# Groundwater Application Review Summary Form

Application # G- 18863

TO: Water Rights Section Date June 14, 2019  
 FROM: Groundwater Section Travis Brown  
 Reviewer's Name  
 SUBJECT: Application G- 18803 Supersedes review of \_\_\_\_\_  
 Date of Review(s)

**A. GENERAL INFORMATION:** Applicant's Name: Kurt and Koreen Metzger County: Marion

### Hydrographs

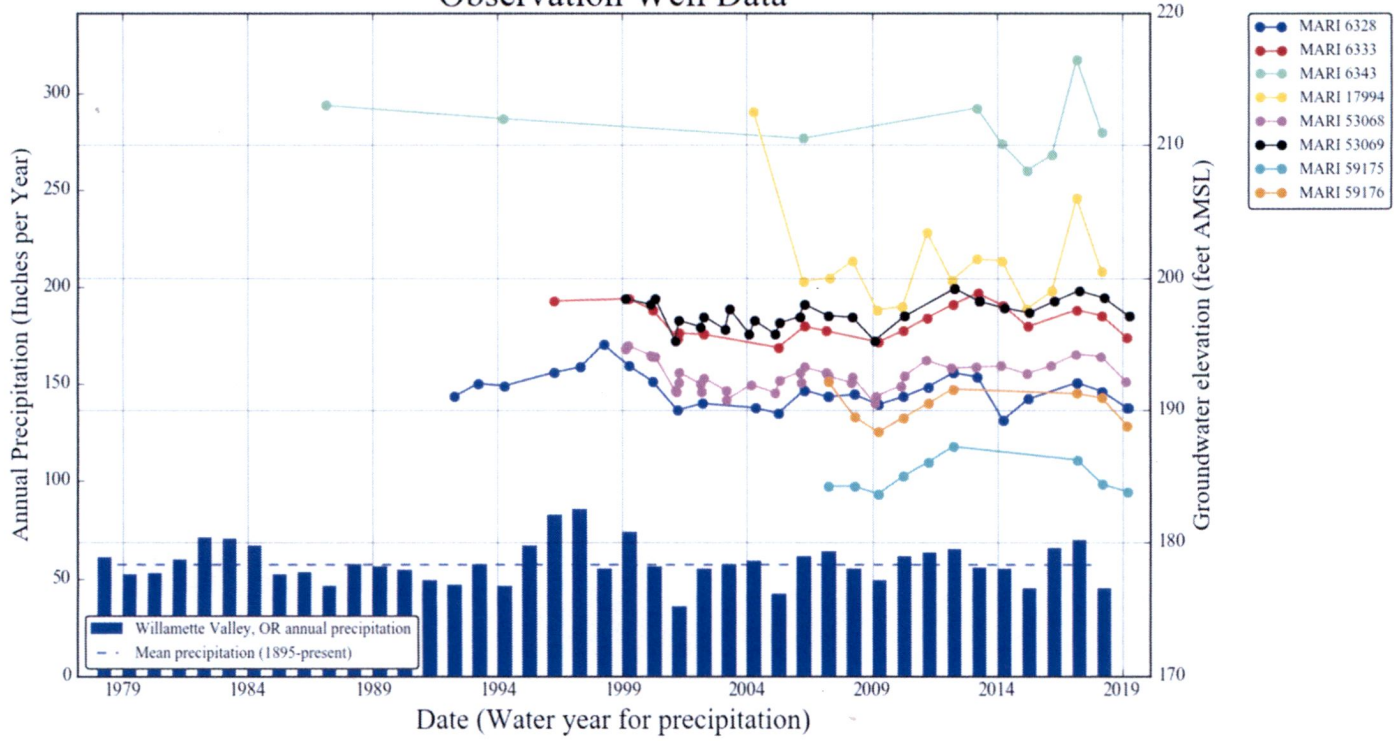
Water levels from nearby observation wells completed in the CRBG aquifer(s) suggest that other groundwater users are using the same aquifer which would be tapped by the proposed POA (see attached Hydrograph). The available water level data does not indicate widespread or consistent declines in the local basalt aquifer over the past decade. However, because pumping impacts will propagate outwards at rapid rates and likely reach the aquifer boundaries, conditions in the aquifer may change quickly.

### Well Statistics

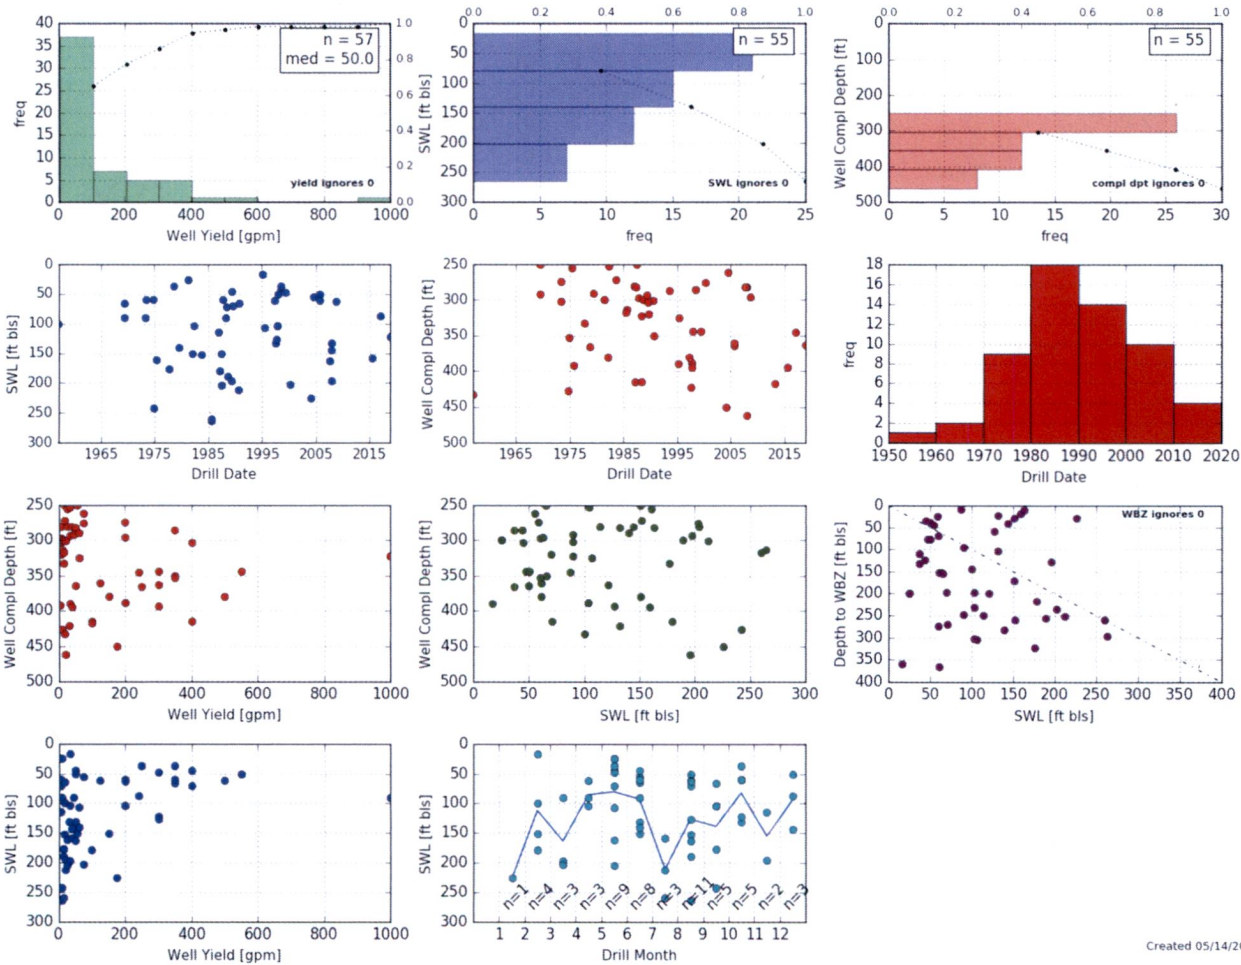
Well statistics for basalt wells completed to similar depths in Sections 17 to 20 of T7S/R1W indicate reported yields ranging from 5 to 1000 gpm, with a median of 50 gpm. To achieve the requested use of 0.895 cfs (401.5 gpm), each of the applicant's proposed wells would need to yield greater than ~200 gpm (~0.446 cfs), which is ~400% of the median reported yield for nearby basalt wells but still within the range of reported yields (see Well Statistics, attached).

### Drawdown Analysis – POA 1

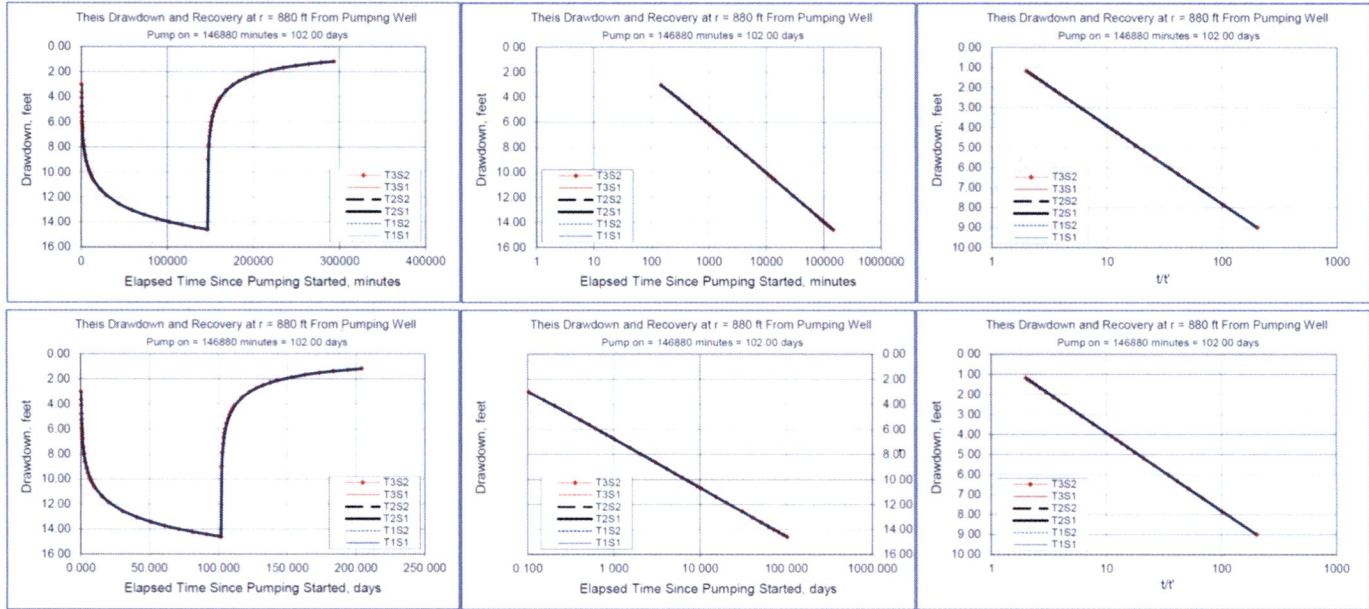
The nearest known CRBG groundwater right to the proposed POA is MARI 6334, an exempt domestic well which appears to be owned by the applicant. The next nearest known CRBG groundwater right is MARI 6335, an exempt domestic well ~420 ft south-southwest of proposed POA 2. MARI 6335 is reportedly ~433 ft deep and appears to be open to both the CRBG and the underlying marine sedimentary unit(s). As such, any interference with MARI 6335 from the proposed POA through the CRBG aquifer(s) may be mitigated somewhat by the influence of water-bearing zones (if present) in the deeper marine sedimentary units. However, drawdown analysis of the proposed POA indicates that interference with MARI 6335 could exceed 15 ft within less than 24 hours, assuming constant pumping from both proposed POA simultaneously at 200 gpm each (400 gpm / ~0.89 cfs total) (see attached Drawdown Analyses. **Note: Drawdowns from POA 1 and 2 are additive**). Under the standard condition for basalt aquifers in the Willamette Basin, Condition 7i, the requested use would need to be curtailed if hydraulic interference exceeded 15 ft in any neighboring well providing senior exempt uses or covered by prior rights. **Because there is a significant potential that the well would need to be curtailed under Condition 7i within such a short period of time, groundwater for the proposed use will not likely be available in the amounts requested without injury to prior water rights.**

**NOTE: This evaluation considers a conservative scenario for the nearest authorized POA not owned by the applicant. Other authorized POAs in the area may also experience an increase in interference as a result of this application, although to a lesser extent than the scenario evaluated here. If a permit is issued for the requested use, it is recommended that the conditions specified in B(1)(d)(i), B(2)(c), and B(3) Special Conditions be applied to protect existing users and monitor the resource.**
